DEVIATION REQUEST AND DECISION FORM

Project Name : Hay Creek Valley Subdivision
 Schedule No.(s) : 7133007014, 7133000001, 7100000270, 7100000267, 7100000268, 7100000269
 Legal Description : See attached

HAY CREEK VALLEY SUBDIVISION
 PRELIMINARY PLAN

SP03

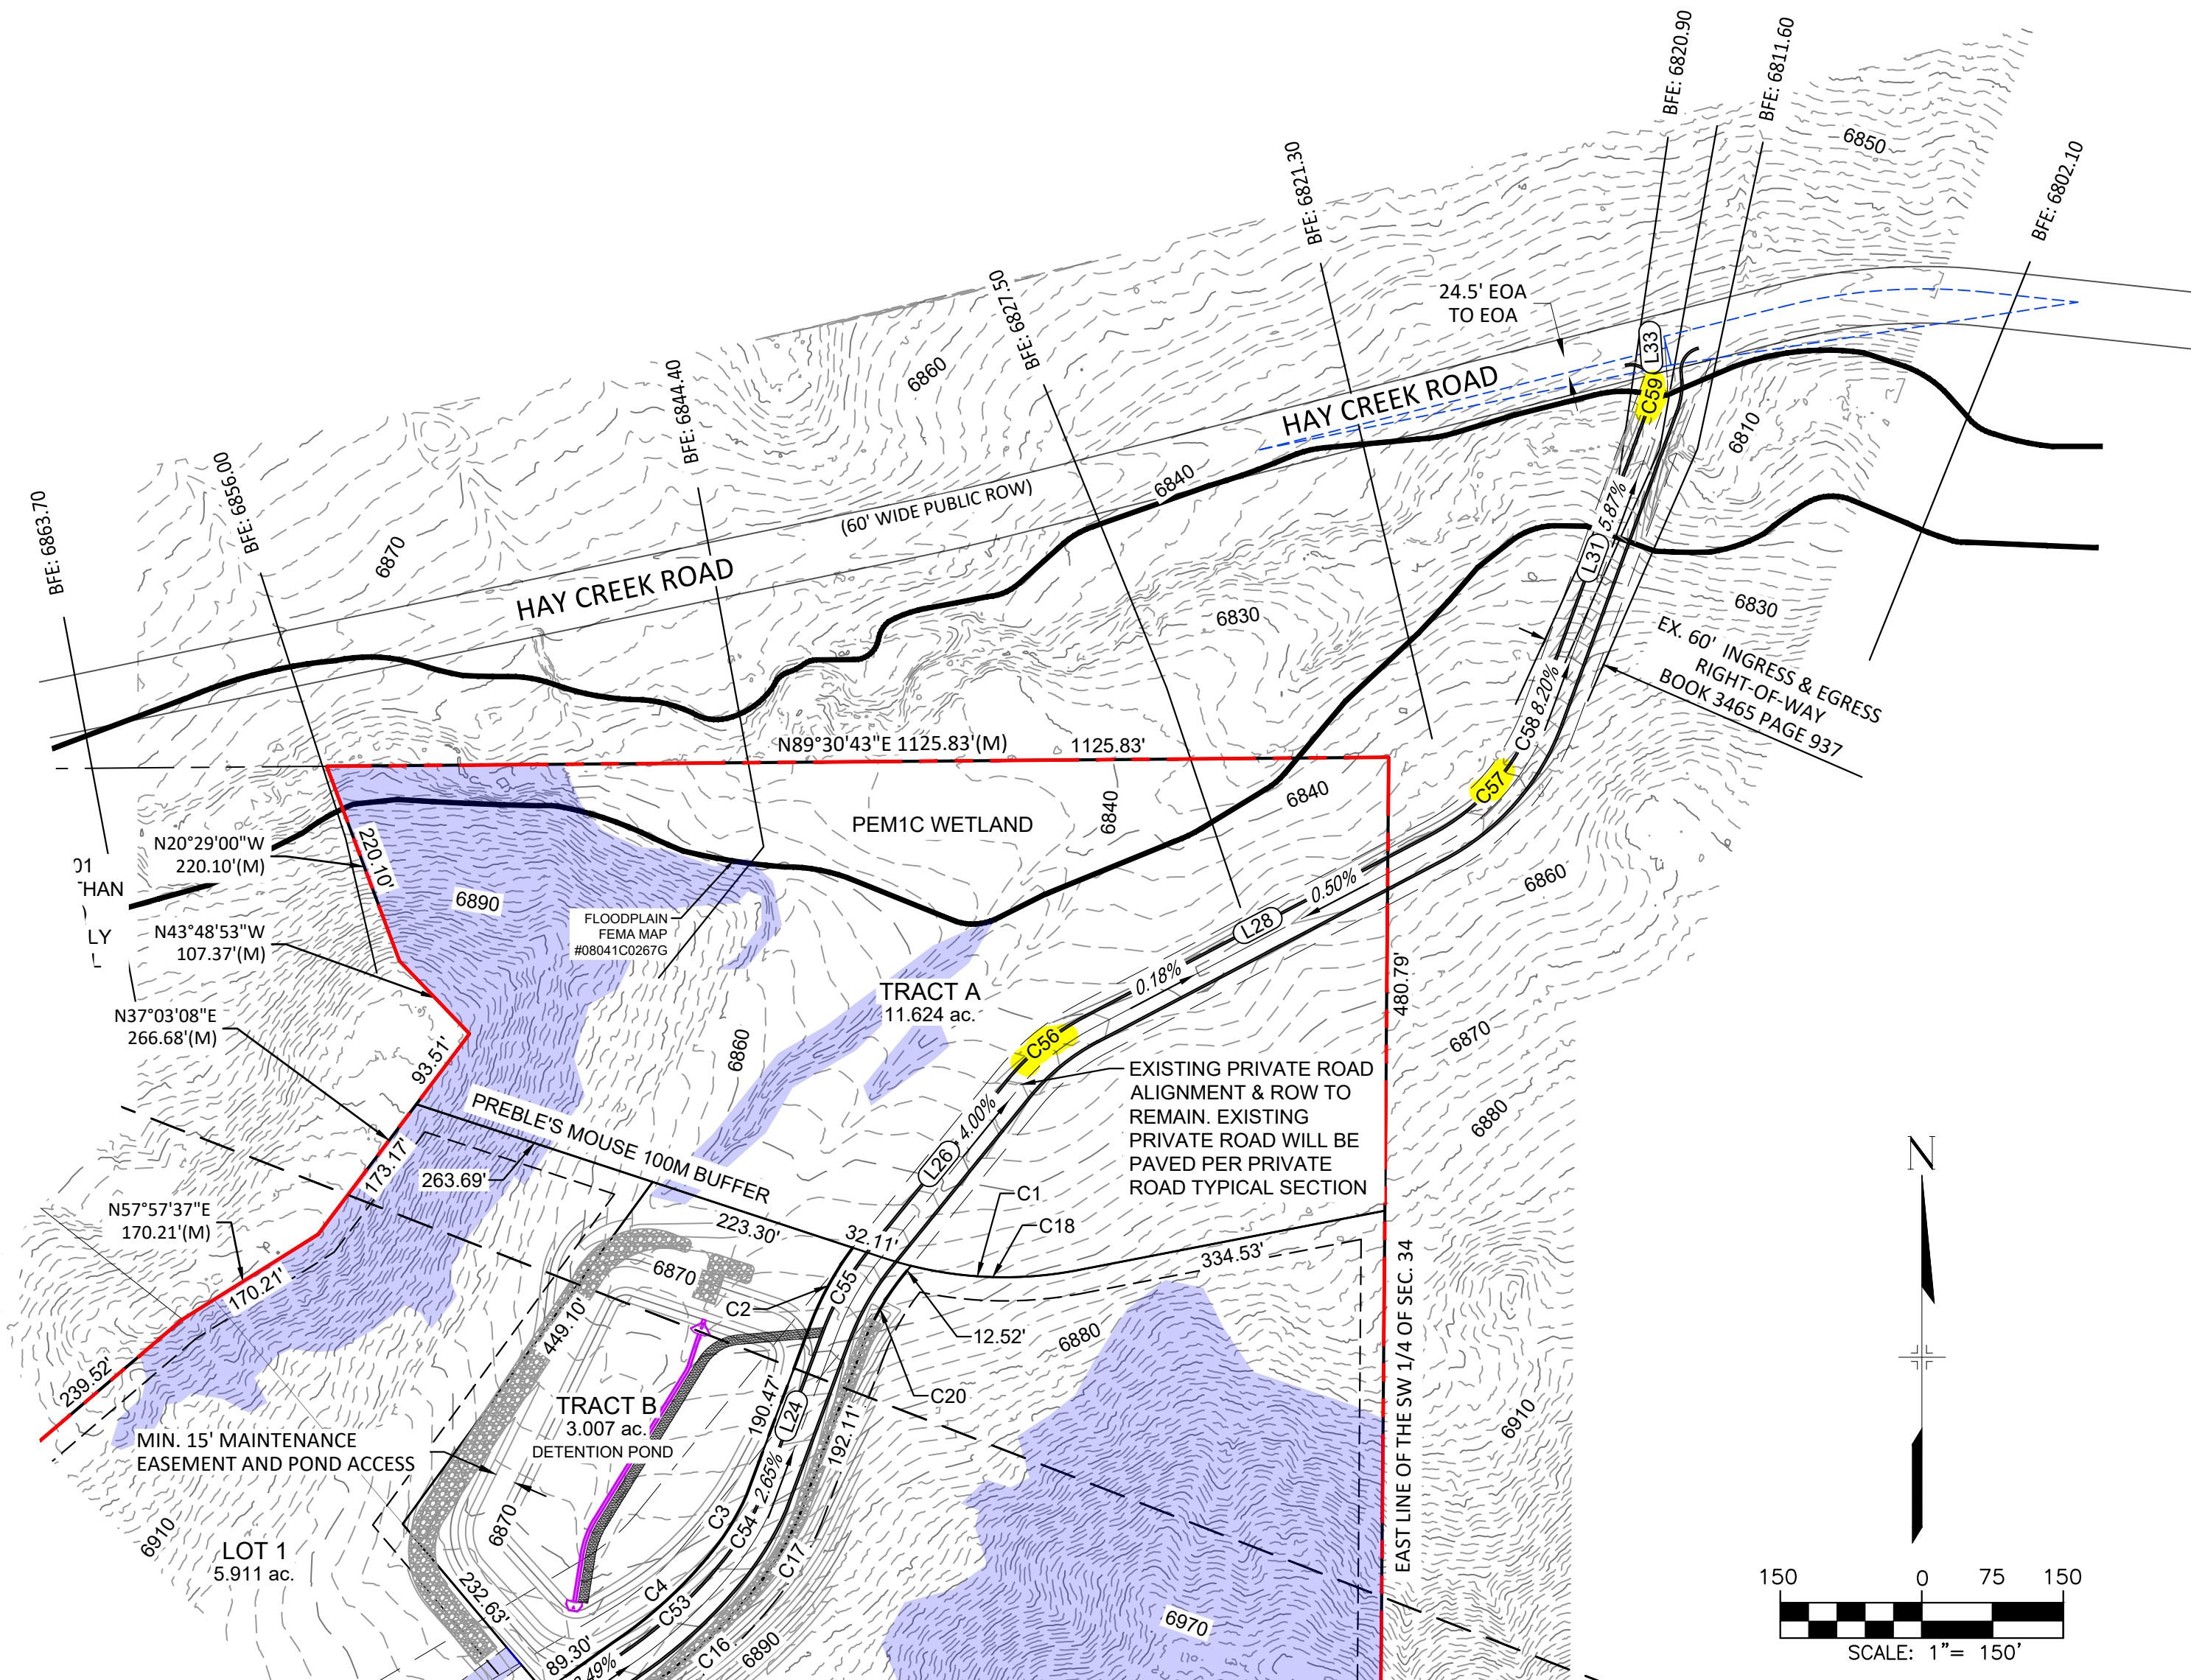
Approved deviation only applies to curves C56, C57, C59 which are located in an existing easement offsite as described above.

Roadway alignment at curve C54 must be revised with the subsequent final plat application to meet criteria.
